MEMORANDUM

FILE NO.: PDP2014 0001

PROPOSAL: Preliminary plan approval for a 12 unit Planned Unit Development in the D-3 zoning district

North Douglas Planned Unit Development

Planting Plan
SHEET #:
L100

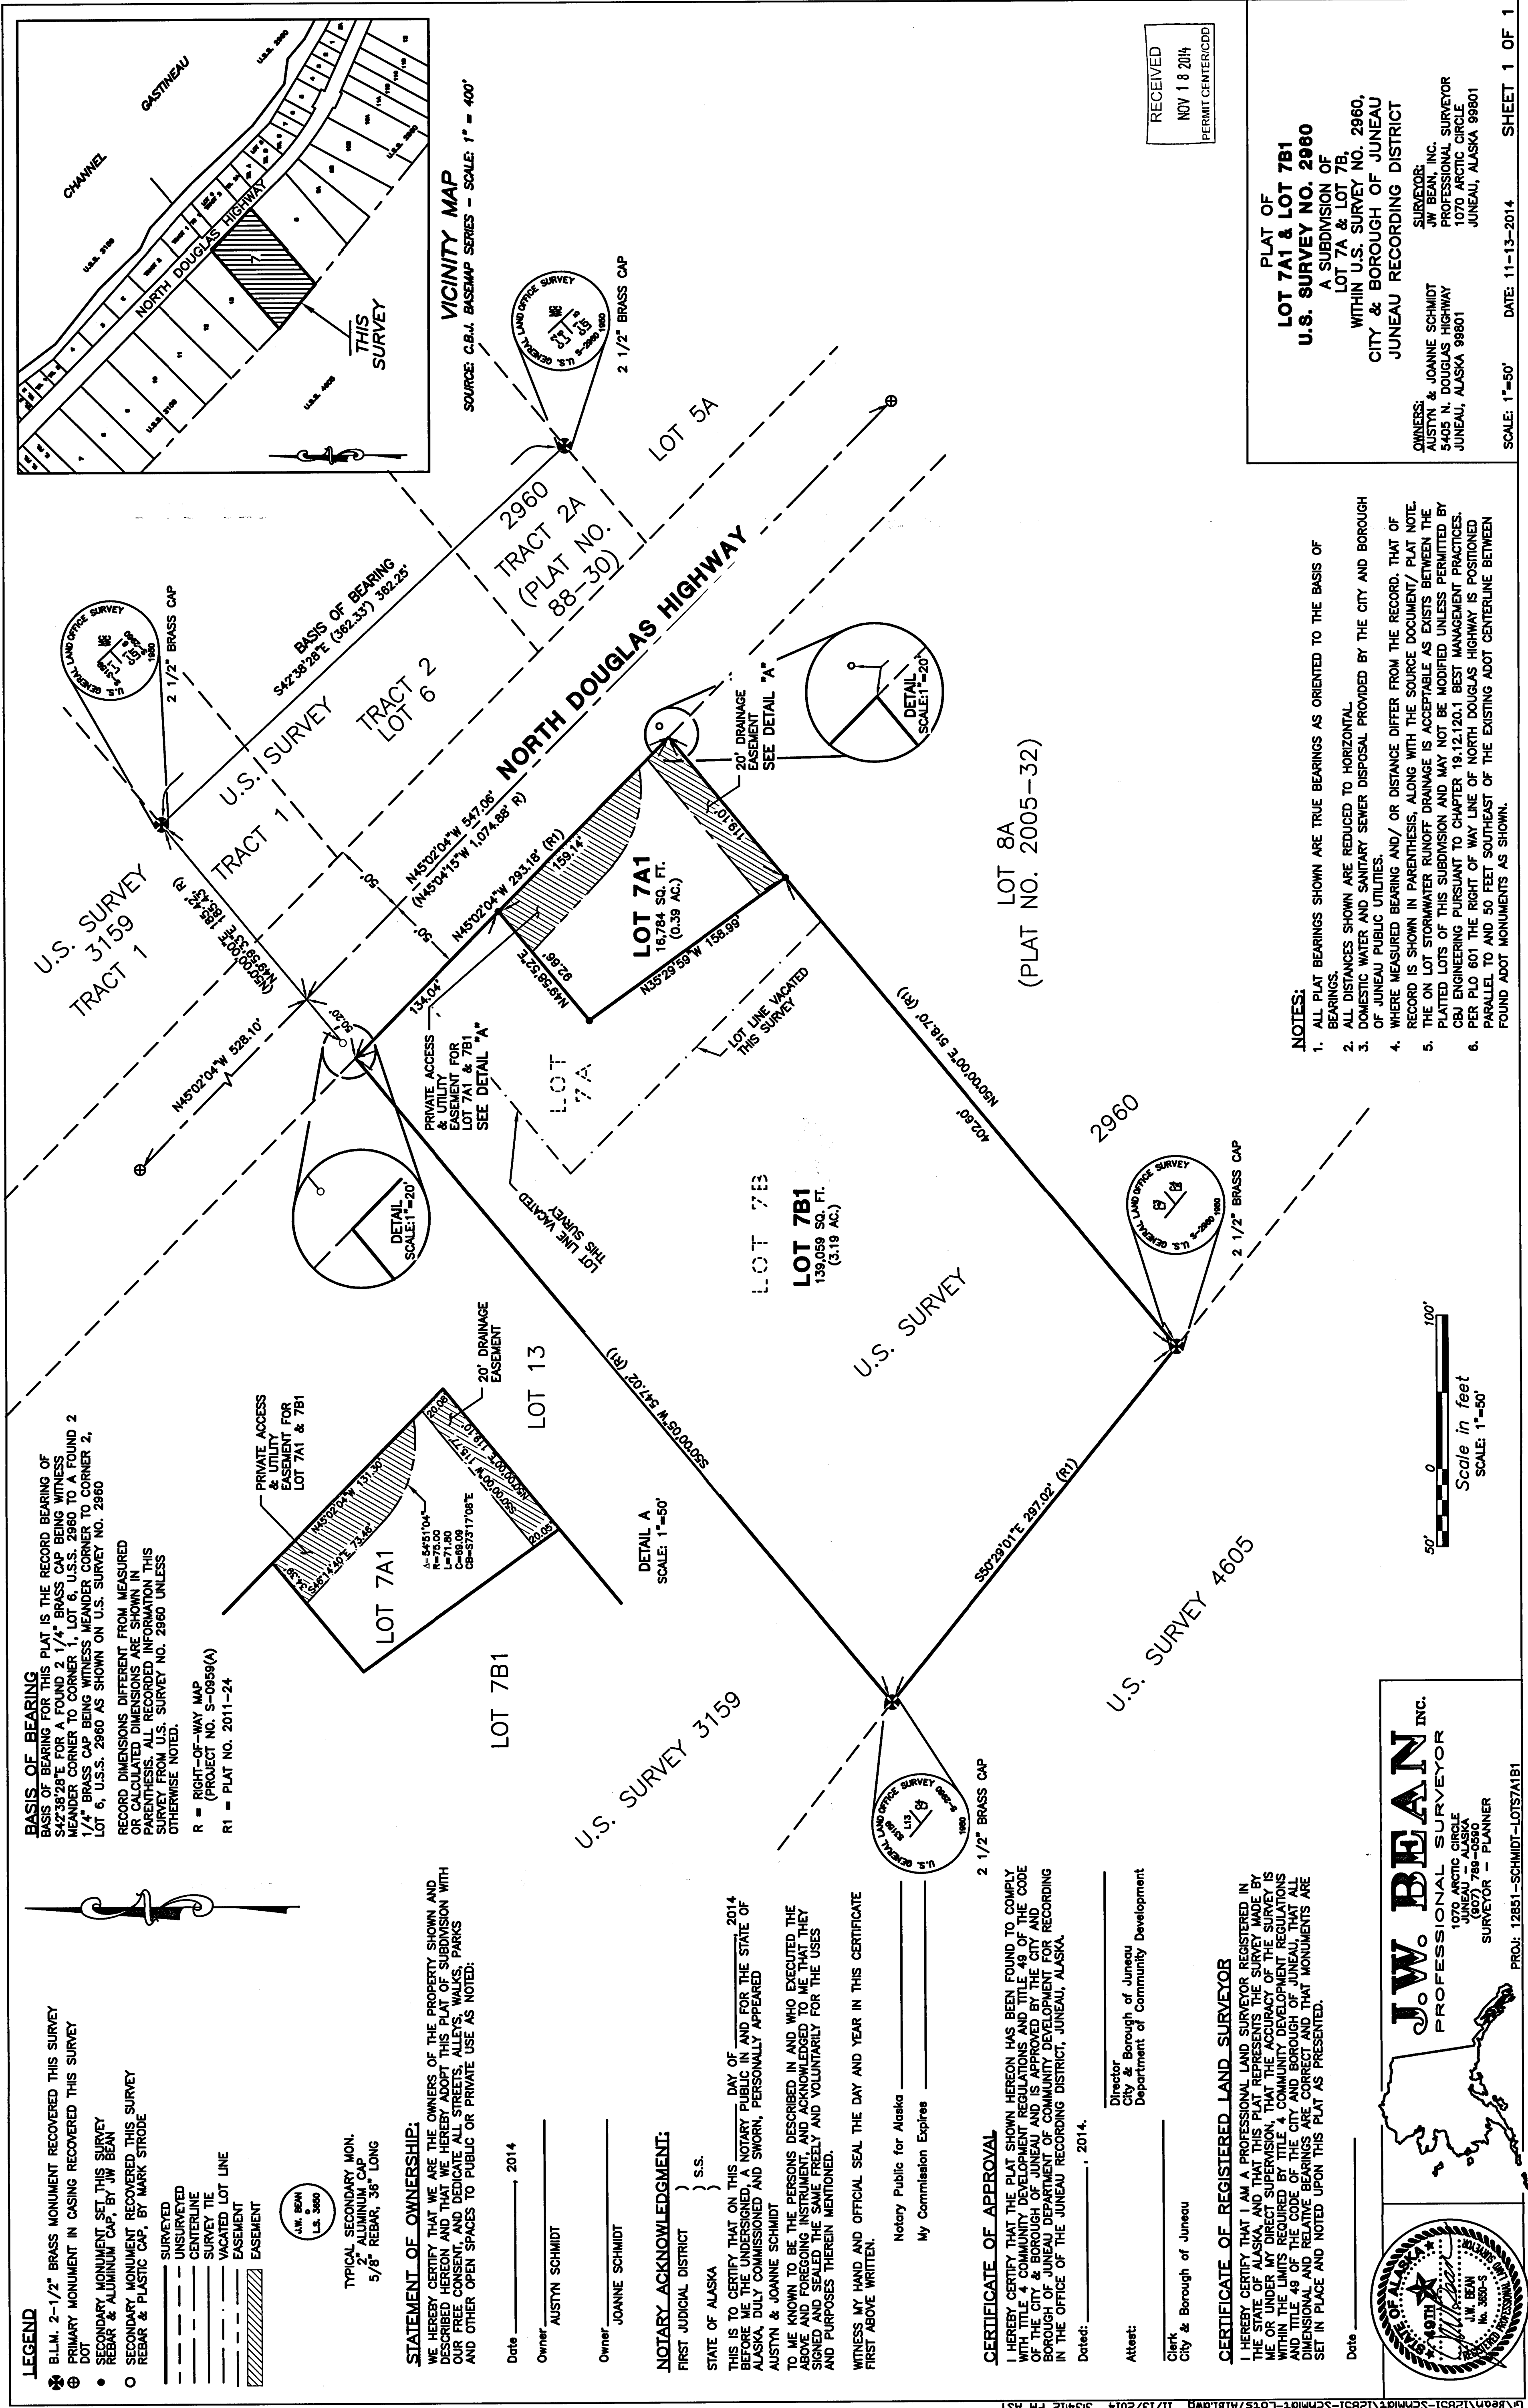
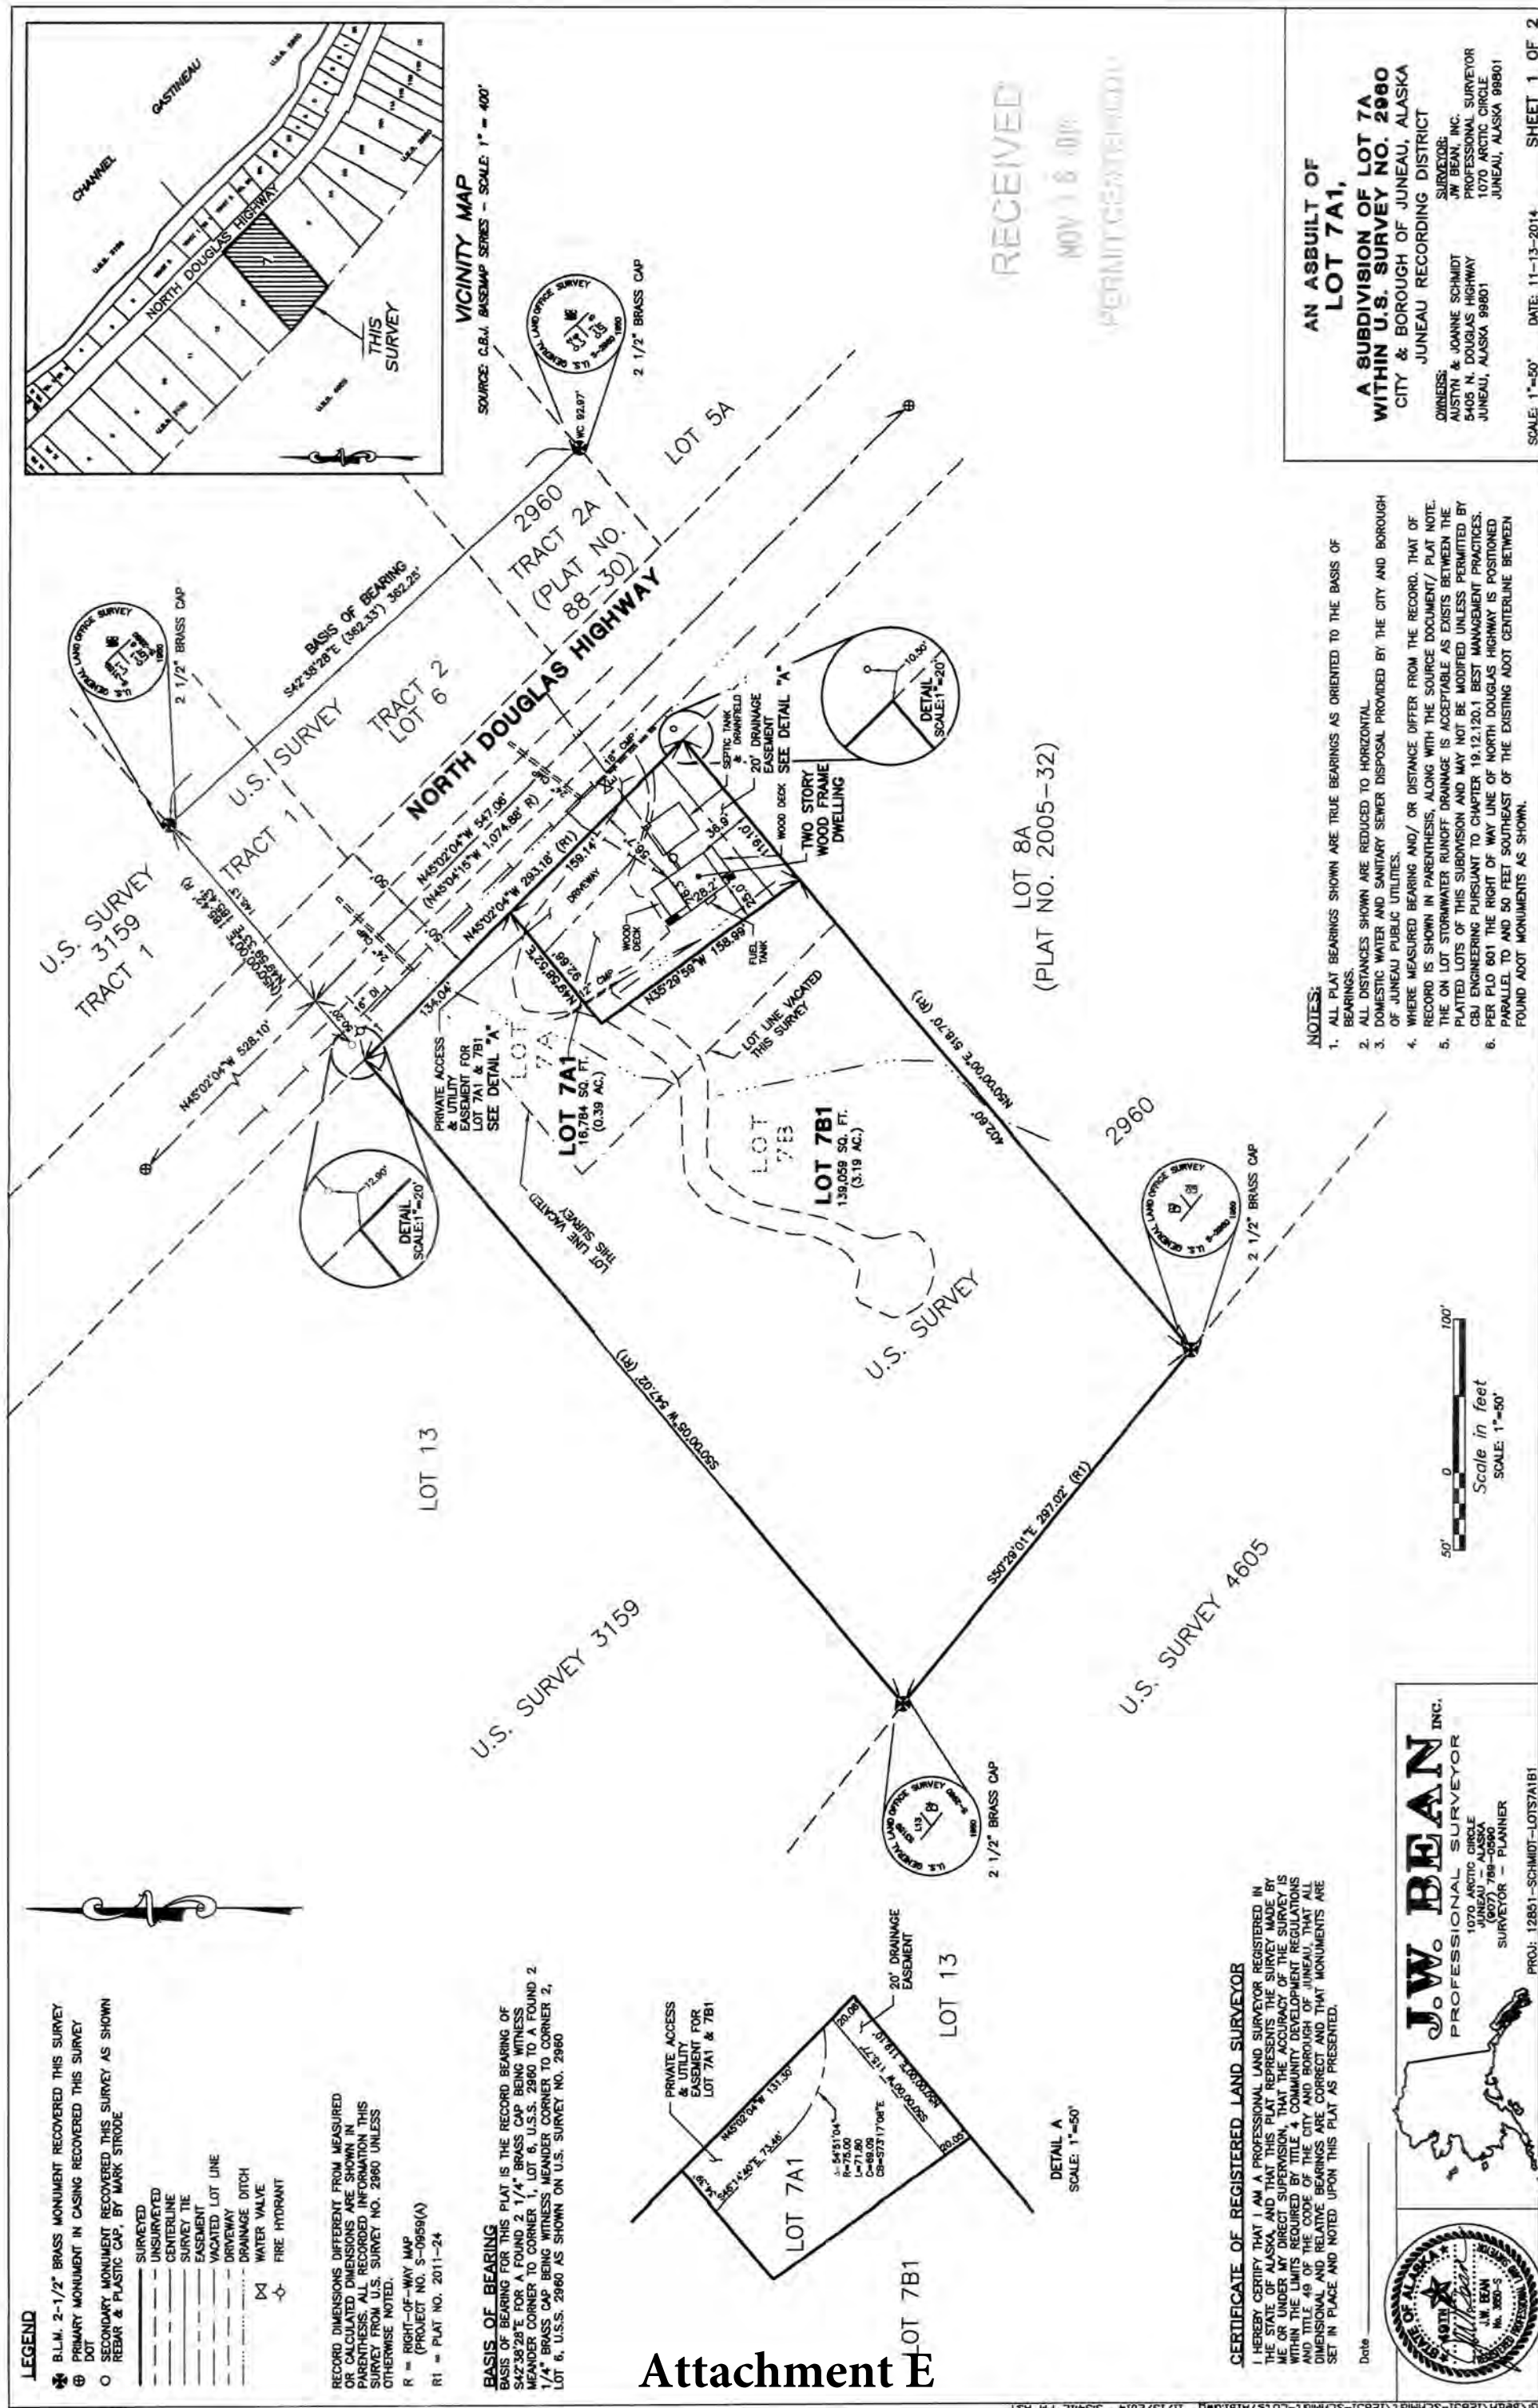
Perimeter Buffer. CBJ 49.15.670(e) requires a minimum 25 foot perimeter buffer “between the exterior boundary of the planned unit development and the nearest structure, road, or parking area within the development...” The common driveway comes to within 10 feet of the north and south exterior boundaries. As a condition of final plan approval, staff recommends the applicant either redesign the driveway to meet the 25 foot perimeter buffer standard or apply for a Variance to the design standard.

Access and Vehicular Circulation. The common driveway will connect to the current access for Lot 7A (Attachment B). The driveway is designed with a slope of 12 percent. The IFC maximum grade percentage is 10 percent. When solicited for comments, CBJ Fire Marshal Dan Jager stated that the applicant must justify why that minimum cannot be met. A steeper grade must be approved by the Fire Marshal.

The proposal identifies an 18 foot wide driveway. However, the International Fire Code (IFC) requires the access road be a minimum of 20 feet wide. The project engineer has amended the design to provide for a 20 foot wide driveway. A Fire Apparatus Turnaround is located at the entry point to the second row of houses. This turnaround has been approved by CBJ Fire.

Pedestrian Circulation. A gravel pedestrian path will be located along the southern boundary line. Pedestrian access will extend from North Douglas Highway along the property and provide access to each tier of housing and the park. This access must be denoted on the proposed plat with an easement across Lot 7A1.

3. Prior to final plat approval a pedestrian access easement will be noted along the southeast boundary of Lot &A1.
4. Prior to the issuance of a grading permit the developer must submit a Temporary Erosion Control plan.

8. Unless granted a Variance, the proposed driveway must be redesigned to avoid the 25 foot no development buffer.
9. The articles of incorporation and bylaws of the homeowners' association, required under AS 34.08 or CBJ 49.15 Article VI, shall be prepared by a lawyer licensed to practice in the state.
